Joint Sub-Committee on Variations
to the Plan of Layout of the City of Canberra
and its Environs

REPORT ON PROPOSALS FOR VARIATION
TO THE PLAN OF LAYOUT OF THE CITY OF CANBERRA
AND ITS ENVIRONS

Third Report on Proposals for Variation
Variation 1988/4

BRUCE: Clews Place - Road Addition

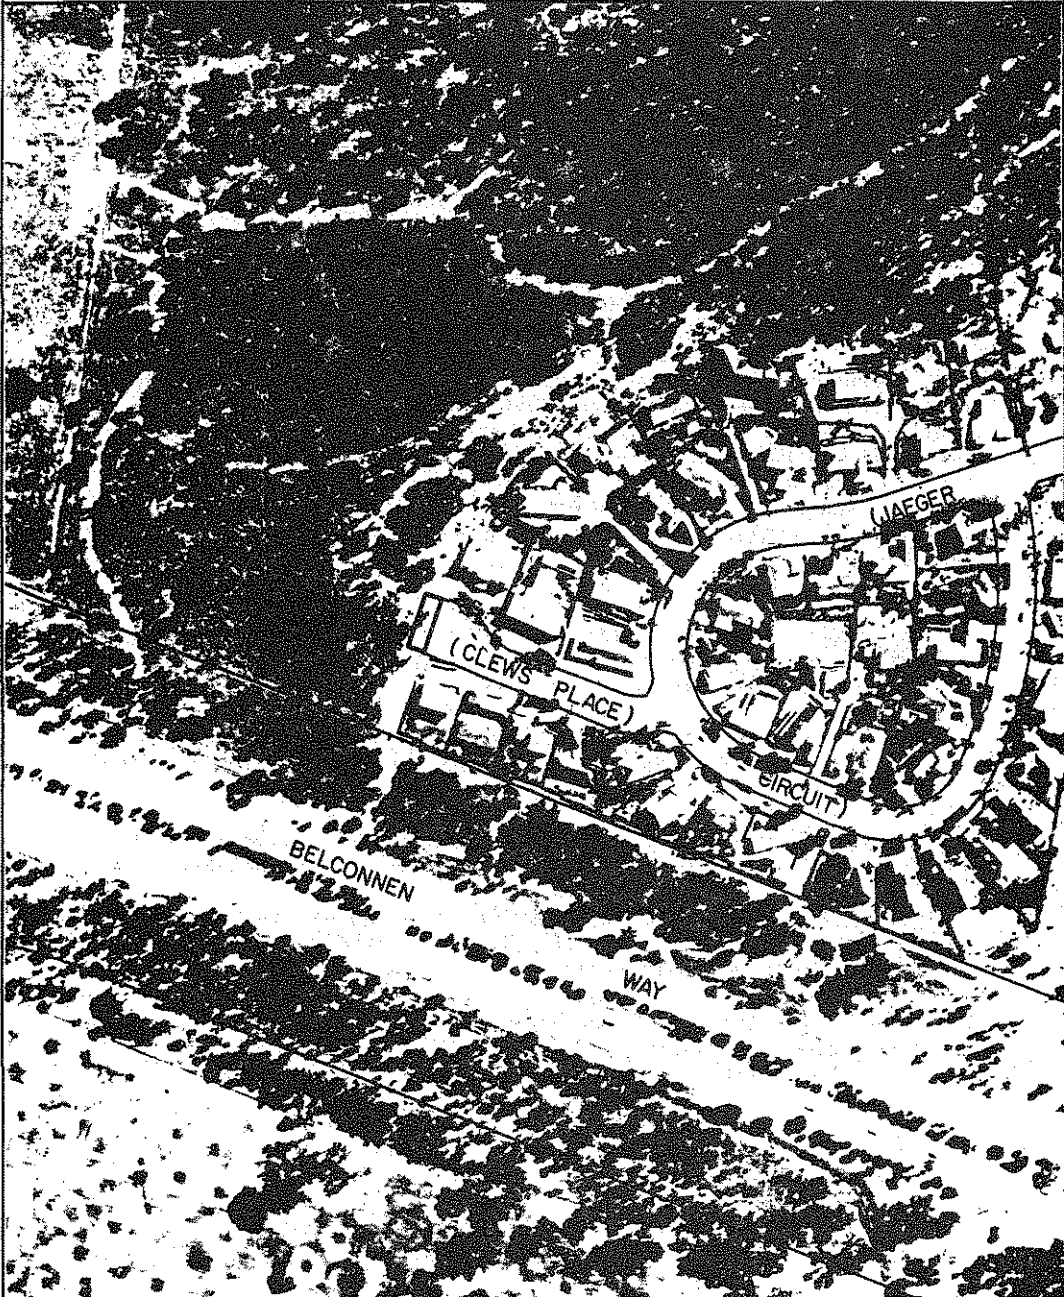
16. Mr Dunstone of 3 Portus Place, Bruce lodged an objection to Variation 1988/4. His objection relates to the Clews Place proposal and the fire/nature trail between the Bruce west and south Bruce developments, which can be accessed at Clews Place.

29. Despite the reservations, the Joint Sub-Committee approves the Variation for the minor road addition at the top of Clews Place.

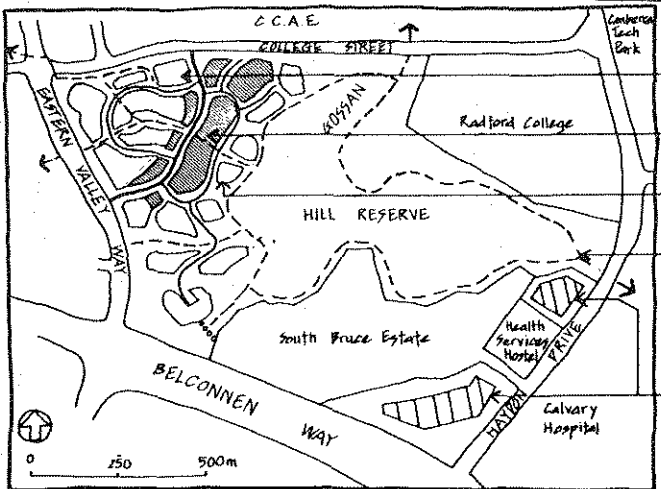
However a 4 to 5 metre wide fully sealed roadway is being constructed. Please refer to attached NCDC letter and photo.

However, the attached photograph shows a house (Clews Pl BRUCE)

which is the antithesis of the development conditions. The latest variation (1988/4) relates to the photographed house and is really only required due to the inability or unwillingness of the authorities to force adherence to the development conditions. The encroachment of the driveway would not have been required if the scale of the house and or design were different.

This in the plan has resulted in the above

It will be a nature trail!
